Verification report for GS4GG project activities

Title of the GS4GG Programme	PoA: "Proyecto Mirador Enhanced Distribution of Improved Cookstoves in Latin America"
GS ID of Programme	PoA: GS1988
Title of the VPA(s) covered	"Proyecto Mirador Enhanced Distribution of Improved Cookstoves in Latin America: First VPA for Distribution of Dos por Tres Cookstoves in Honduras"
GS ID (s) of Project (s)	VPA: GS2758
Version number of the verification and certification report	2.0
Completion date of the verification and certification report	22/07/2025
Monitoring period number and duration of this monitoring period	15 th monitoring period: 01/05/2023 - 31/12/2023 (inclusive of both days) Duration of 3 rd Crediting Period: 01/05/2023 – 30/04/2030 (inclusive of both days)
Version number of the monitoring report to which this report applies	Version 3.3, dated 03/07/2025
Crediting period of the project activity corresponding to this monitoring period	01/05/2023 - 30/04/2030

Proyecto Mirador Foundation has contracted Earthood Services Limited (Earthood) to conduct the verification and certification of emission reductions reported for the GS VPA, GS2758- “Proyecto Mirador Enhanced Distribution of Imp

CL ID	01	Section no.	B.1	Date : 06/01/2025
Description of CL

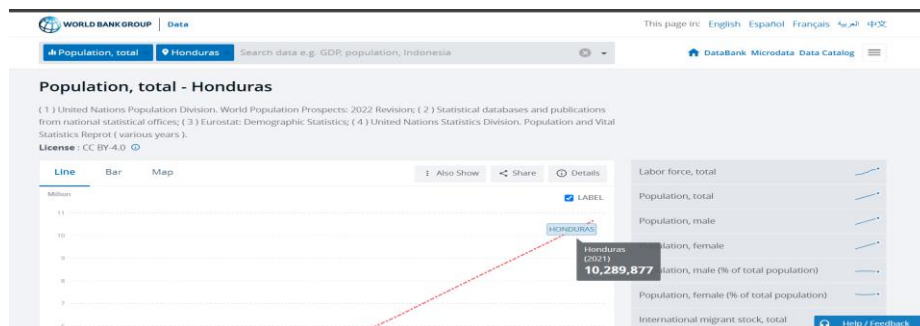
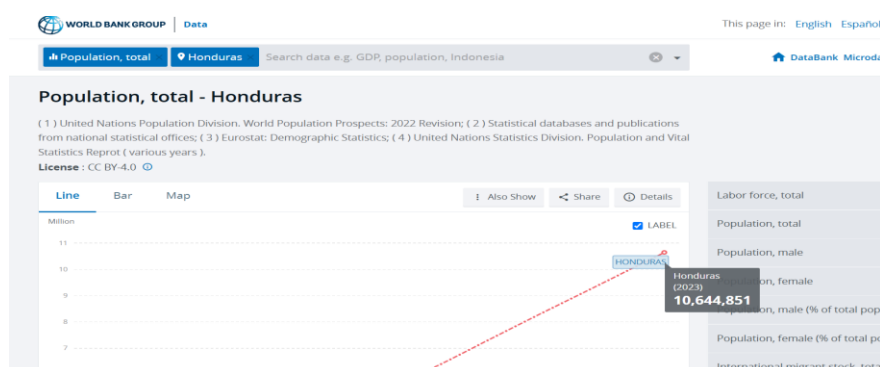
As per Footnote 12 on page number 10 of the MR titled "0 - Mirador VP15 MR v2.0 16 Dec 24", the population of Honduras is mentioned as 10,062,994. However, as per World Bank 2021 the population of Honduras is mentioned as 10,289,877 which can be checked from the below screenshot.

As the project activity has been implemented during 2023, therefore, World Bank 2022 database should be mentioned as the source of population for Honduras. Kindly refer to the below screenshot and link for further cross-check.

Project participant response		Date : 21/05/2025
The discrepancy between the population figure currently cited (10,062,994) and the World Bank's 2021 estimate (10,289,877) is acknowledged. Since the project activity was implemented during 2023, the project developer will adopt the 2022 population figure (10,463,872) as it represents the most recent full-year data available prior to the implementation period. Accordingly, we will revise the footnote to reference the World Bank 2022 population figure for Honduras, which is 10,463,872, as per the link you provided: https://data.worldbank.org/indicator/SP.POP.TOTL?locations=HN		
Documentation provided by project participant		
0 - Mirador VP15 MR v3.0 05 June 25.docx		
VVB assessment		Date : 10/06/2025
As per assessment of the revised GS PD titled '0 - Mirador VP15 MR v3.0 05 June 25.docx', it has been observed that since the project activity was implemented during 2023, hence PD has mentioned the revised World Bank data for 2022 as mentioned above and in Footnote 16 of the GS PD The World Bank. 2022 Honduras population: 10,463,872. The revision undertaken by PD has been found to be appropriate as it reflects the population as per the latest data from World Bank (2022). CL#01 is Closed.
